Planning Commission Meeting

4.I. 464 Porsche Ave., 0 S. Central Ave., and 0 South Street Preliminary Plat Review

4.II. 464 Porsche Ave., 0 S. Central Ave., and 0 South Street Site Plan Review

SITE PLAN

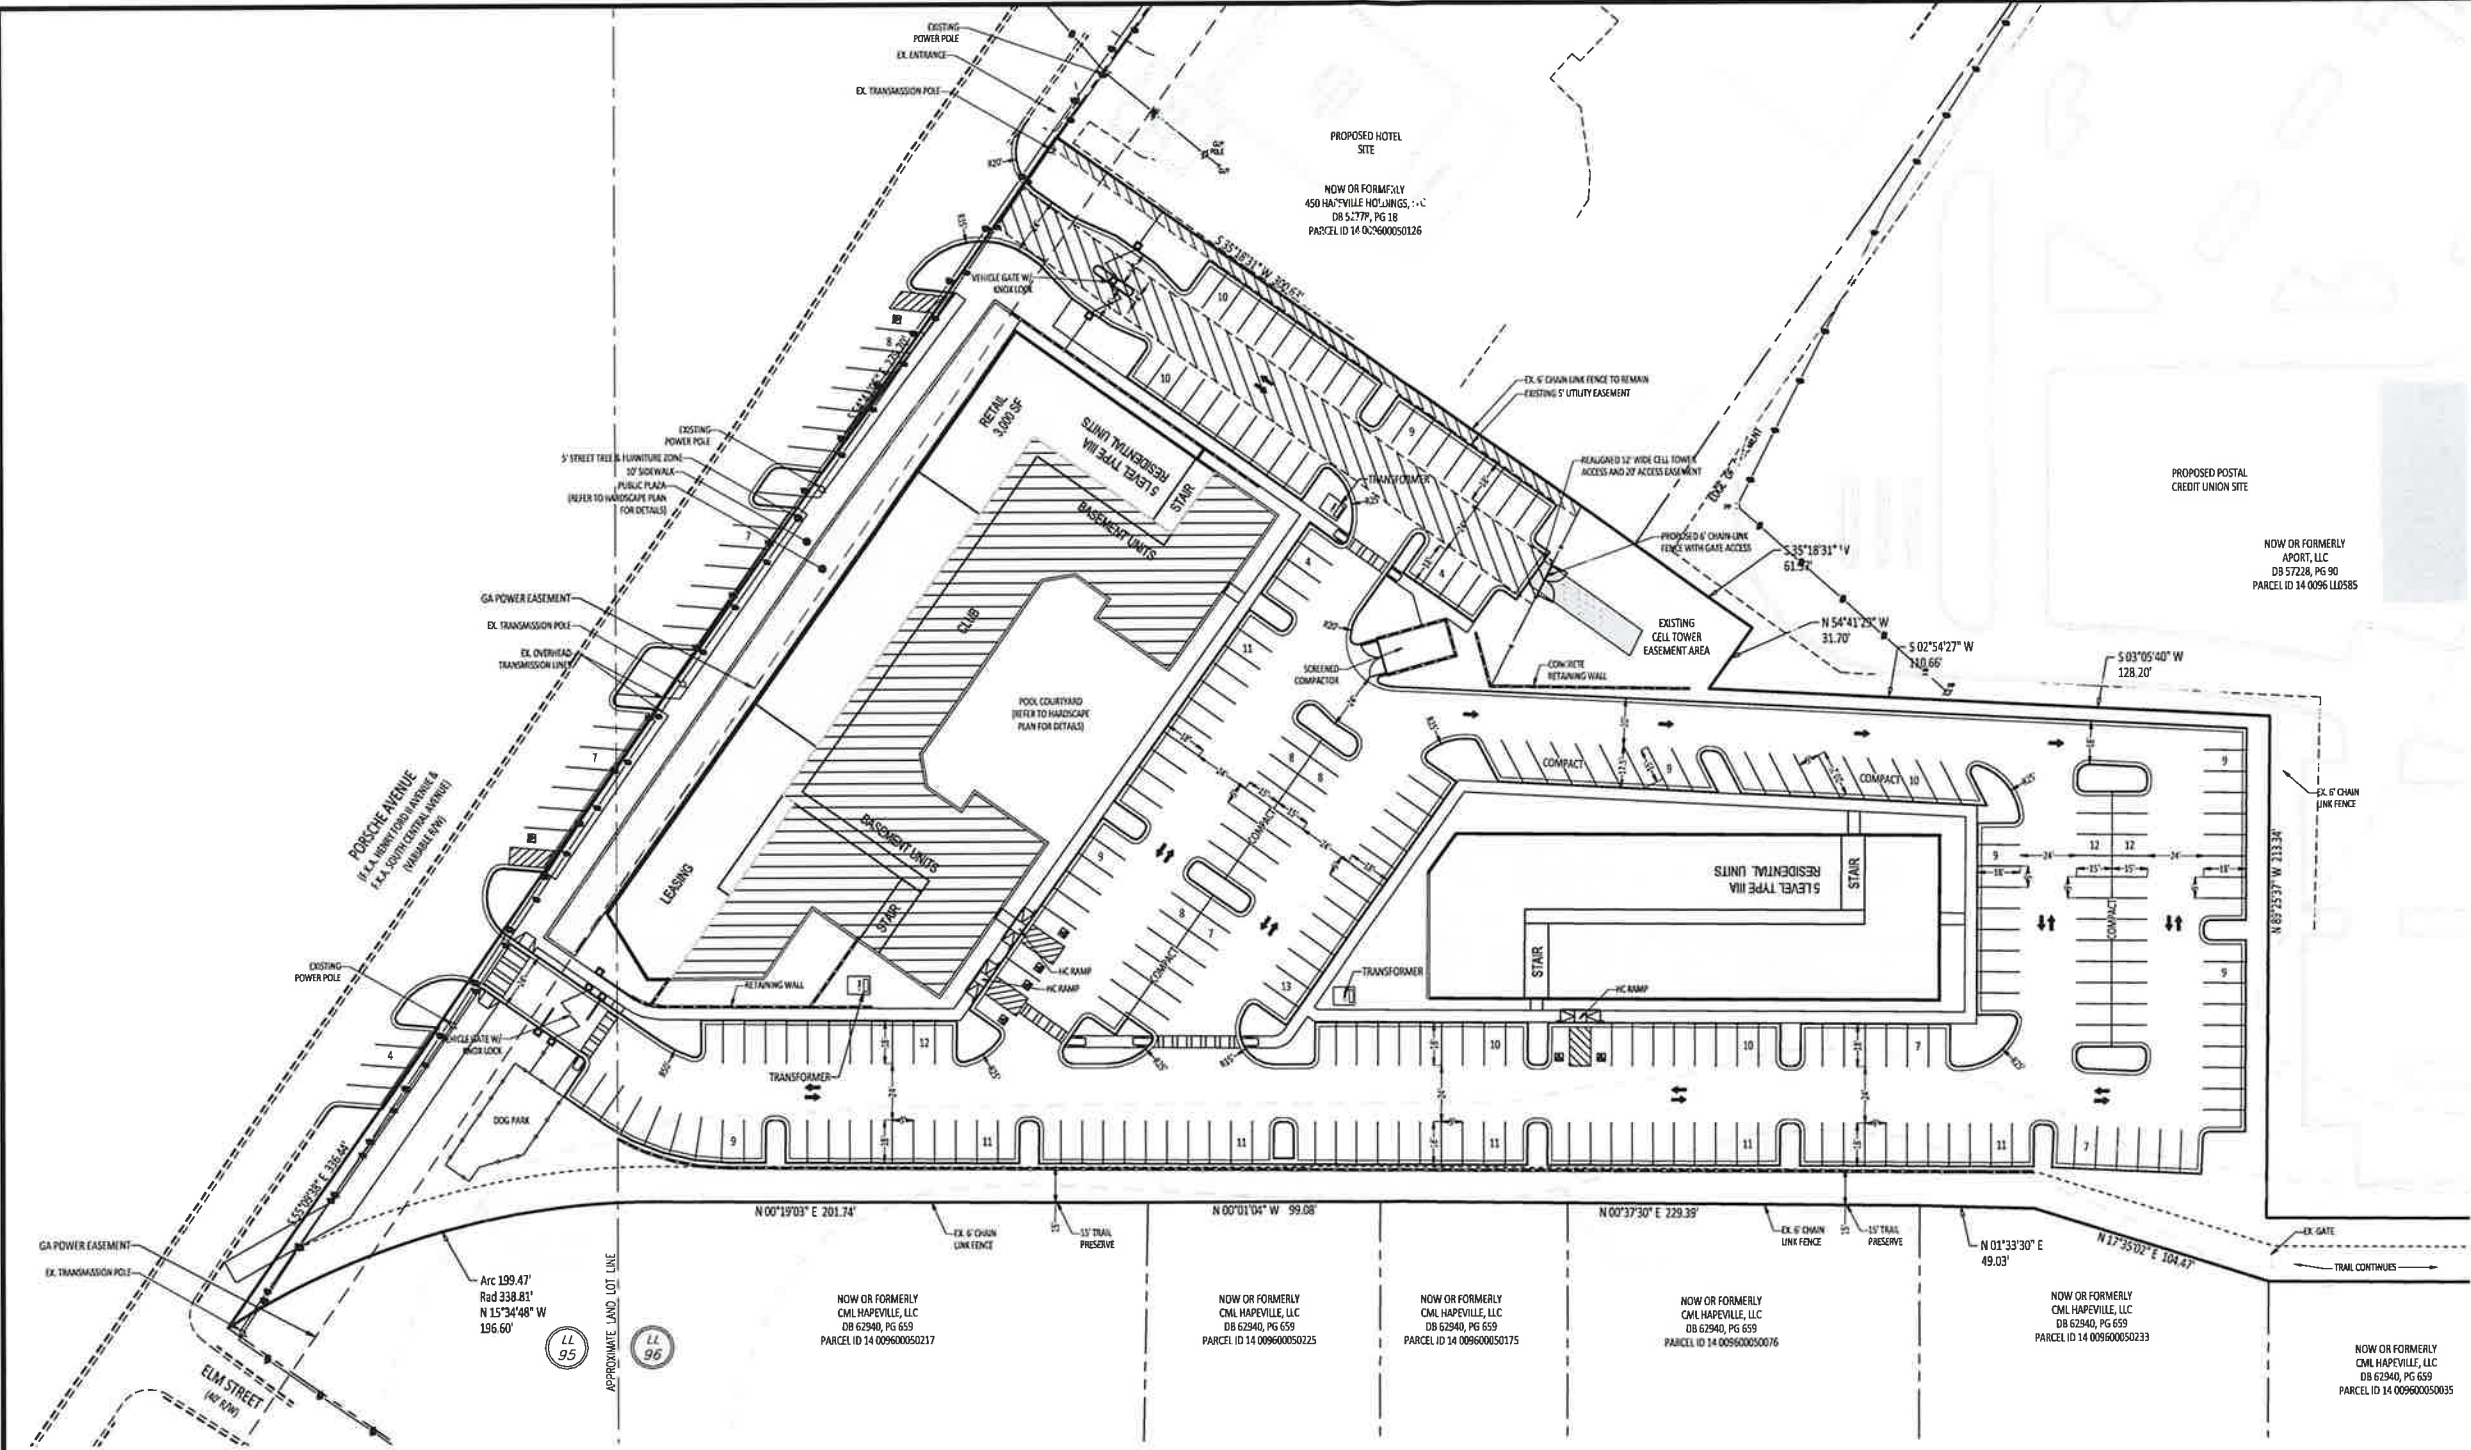
The site plan is deficient for zoning in the following areas:

- Ensure any balconies do not encroach beyond the property line.
- Provide bicycle / moped parking not shown.
- Provide dimensions between trees not provided along Porsche Ave (30').
- Provide Sec. 93-11.2-12. - Commercial design ground floor requirements.
- Provide missing sidewalk on northeast portion along Porsche Drive.
- Provide missing cross sections.
- Seek variance for excess of 110% of parking
- Provide loading space.
- Add one more accessible space on-site (in addition to the one off street parking space)
- Provide impervious surface by type. Coverage should include all impervious surface and breakdown by type (building, parking, driveway).
- Call out materials and include on eastern most entrance/exit.

It is not clear whether the GDOT will require an accel/decel lane which may impact the site plan. The applicant should confirm with GDOT and the City Engineer.

4. The applicant should clearly identify the zoning of the adjacent properties.
5. A portion of the Site Development Data on Site Plan sheet 1 of 2 is not legible and appears to be hidden text.

9. The fire chief should verify the interior driveway widths shown are sufficient for emergency vehicle access.
10. While this submittal review is for concept site plan approval only, the applicant should be aware that submittal and review of detailed site construction drawings will still be necessary prior to land development permitting.
